**SUNDRY NOTICES AND REPORTS ON WELLS**  
*Do not use this form for proposals to drill or to re-enter an  
abandoned well. Use Form 3160-3 (APD) for such proposals.*

8. Well Name and No.  
HJ Federal #1

**Bone Spring Recompletion Procedure**

**HJ 13 Federal 1  
30-015-23781  
Lynx Petroleum Consultants, Inc.  
August 29, 2013  
Conditions of Approval**

PROPOSED BONE SPRING RECOMPLETION  
08/01/13

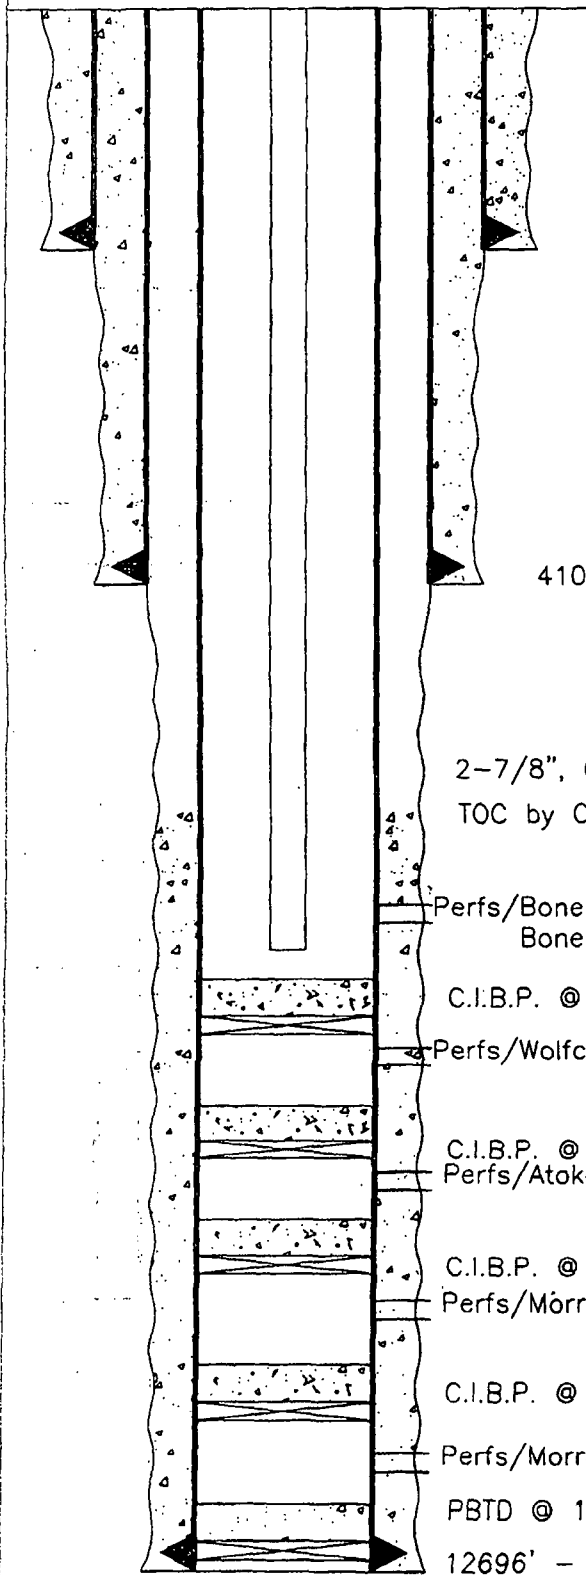
- 1. Tag cement at 11,715'. If tag is shallower than 11,715' operator shall pump 25 sx class H cement and tag.**
- 2. Operator shall set CIBP at 11,380' and place 215' of cement on top. Tag at approximately 11,165'.**

- 3. Must conduct a casing integrity test before perforating and fracturing. Submit results to BLM. The CIT is to be performed on the production casing to max treating pressure. Notify BLM if test fails.**
